# Car Stereo Service Bulletin

**Model:** XR-U550

**No. 305**

**Subject:** CAUTION ALARM is not easily audible.

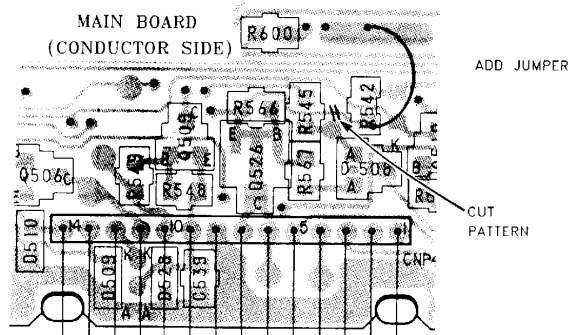
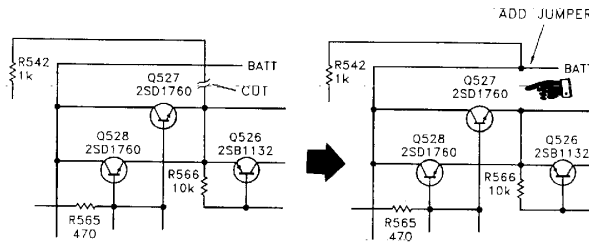
(52) The customer may complain that the CAUTION ALARM is not easily audible.

If the customer complains of this, make the following circuit changes to increase the volume.

- 1- Cut the pattern between R542 and the emitter of Q527.
- 2- Add a jumper wire between R542 and the BATT line as shown below.
